Date: April 29, 2009
To: Kevin Cox, P.E.
Mark Libby, P.E.
HDR Engineering, Inc.
From: Timothy J. Pfeiffer, P.E.
Subject: Foundation Report Amendment
Permanent Shaft Casing at Abutments
Project: Interstate 5/SR 501 Interchange Replacement

In our final Foundation Report dated March 10, 2008, we presented design parameters for 3-foot diameter shafts at the abutments. The design included 3-foot diameter permanent casing in the upper ± 20 feet of the drilled shafts. At your request, we have prepared the following addendum to our Foundation Report to provide design parameters for 4-foot diameter shafts without permanent casing at the abutments.

FIGURE 1. CALCULATED AXIAL DRILLED SHAFT RESISTANCE vs. ELEVATION

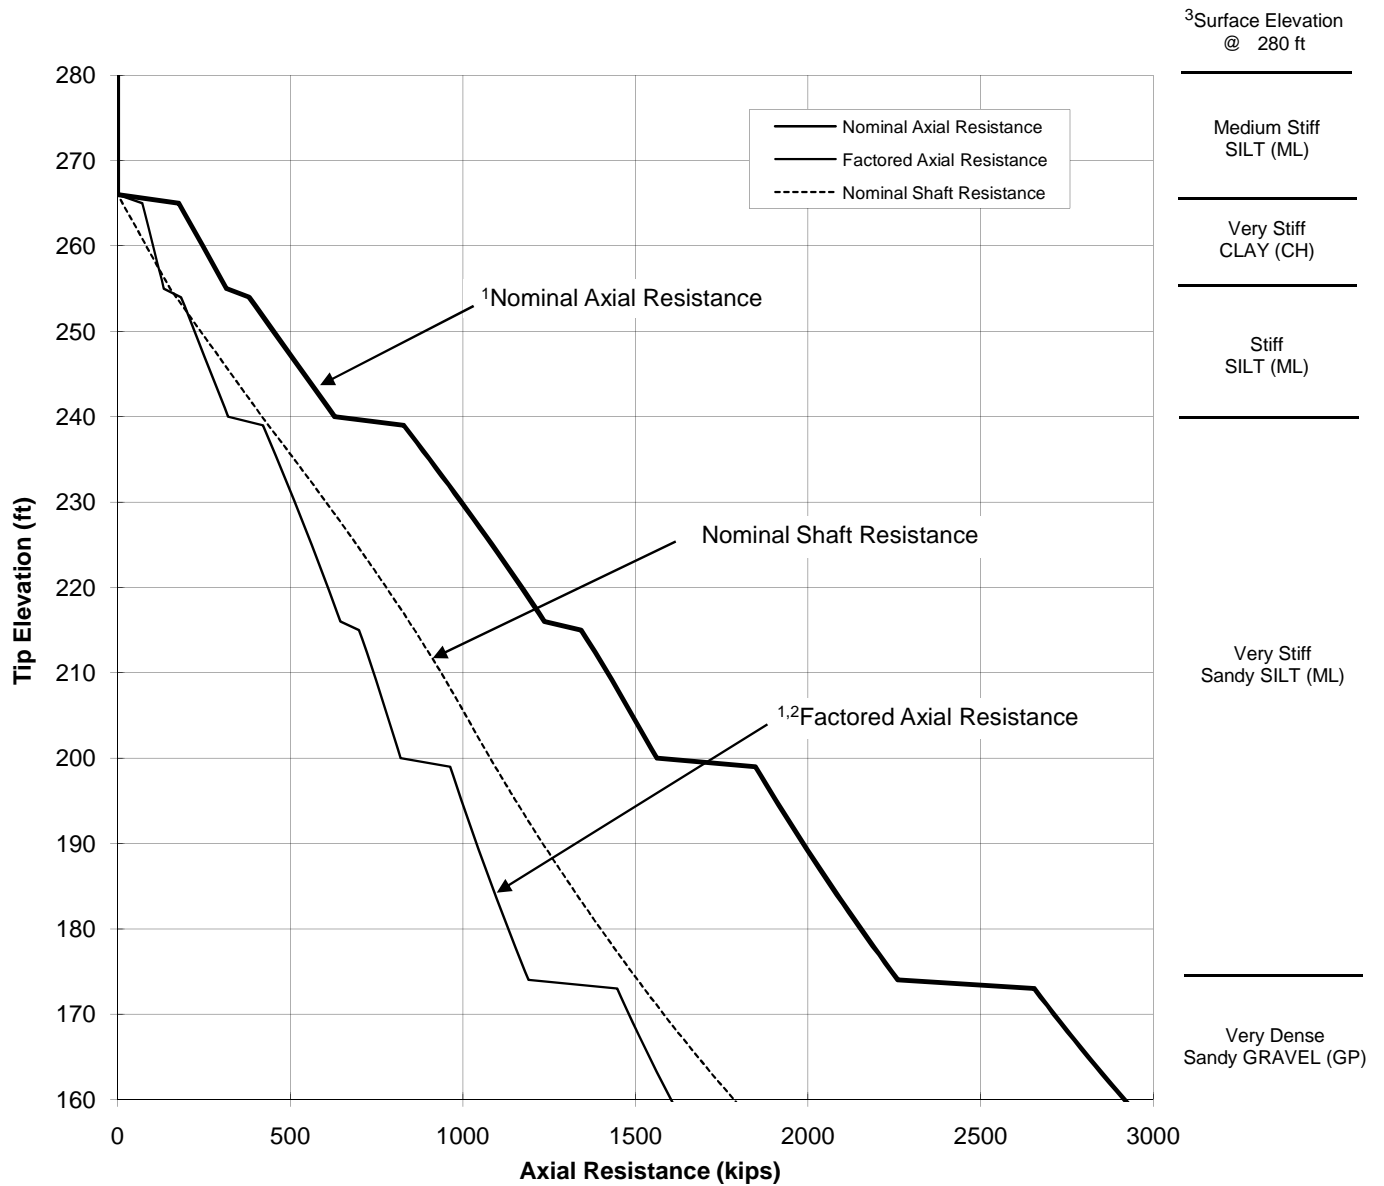
Nominal and Factored Axial Shaft Resistance. The nominal axial resistance versus embedment depth for the drilled shafts was calculated using analytical methods outlined in the FHWA publication IF-99-025; "Drilled Shafts: Construction Procedures and Design Methods" (1999). The calculated nominal axial resistance, factored axial resistance, and nominal uplift resistance versus elevation are summarized on Figure 1 (attached) for the abutments. The fill and the upper ± 15 feet of the soil profile was not included in the shaft resistance.

Uplift Resistance. The nominal uplift resistance of the drilled shafts was calculated using the nominal shaft resistance and appropriate LRFD factors. The values for the nominal shaft side resistance are shown on Figure 1 (attached) for the abutments. The dead weight of the shaft is not included. Table 1 presents the calculated nominal shaft resistances. A resistance factor of 0.45 should be applied to strength state uplift loading conditions and a resistance factor of 0.8 should be applied to the nominal shaft resistance for extreme event uplift loading conditions.
